MONTGOMERY COUNTY HISTORIC PRESERVATION COMMISSION STAFF REPORT

Address: 2410 Spencerville Rd., Spencerville Meeting Date: 7/29/2020

Case Number: 15/55-20A Tax Credit: n/a

Proposal: Solar array and associated fencing

Figure 2: Detail aerial of the Spencer-Carr House site (historic house circled in yellow).

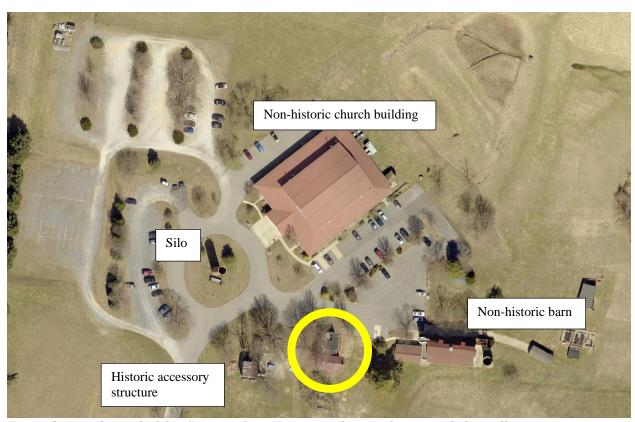
The applicant proposes installing an 8.62-acre commercial solar array to the north of the contemporary church and nearly 400' (four hundred feet) to the north of the historic Spencer-Carr House. Aside from the solar panels themselves, there will be two above-ground features to the northeast of the church building: the 'switchgear' and 'electrical equipment pad.' This location was selected because the church building blocks the view of these features from the Spencer-Carr house. All other conduit will be buried and will not have a visual impact on the site.

The solar panels will be installed in south-facing rows. The panels will be installed on metal posts, embedded directly into the soil, at a fixed angle to maximize collection. Each row of the array will be approximately 13' 4" (thirteen feet, four inches) wide and has a maximum height of just over 8' (eight feet).

Surrounding the solar collector, the applicant proposes to construct a 7' (seven-foot) tall chain-link fence. Staff finds that a fence in this location should be as transparent as possible or should have a utilitarian

character. Because of the desired height for the fence for safety, Staff finds that chain link is an appropriate material.

Outside of the fence, the applicant proposes installing a 20' (twenty-foot) vegetative screen. The screen will be made up of a variety of shrubs, evergreen trees, and canopy trees. Landscape plans are attached. While the HPC is supposed to exclude vegetation when evaluating a HAWP, this space will limit views of the solar collector from within the site.

Staff finds that the proposed solar array will not have a significant impact on the historic Spencer-Carr house for two primary reasons, both discussed at the April 22 Preliminary Consultation. The first reason Staff finds the array will not have a significant impact on the character of the historic house is that the array is a sufficient distance from the historic house. The second reason Staff finds the array will not have a significant impact on the historic house is because the non-historic church building will visually obscure the array from the historic house. Staff finds this comports with 24A-8(b)(2) and Standards 2 and 9 of the Secretary of the Interior's Standards for Rehabilitation.

Additionally, because the posts are being dry laid, at the end of the lifespan of the solar panels, the array can be removed and the site returned to its current appearance, making the proposal compliant with Standard 10.

Staff recommends the HPC approve the HAWP and recommends the HPC direct Staff to conduct a review of the project and brief the HPC after the installation of the solar array.
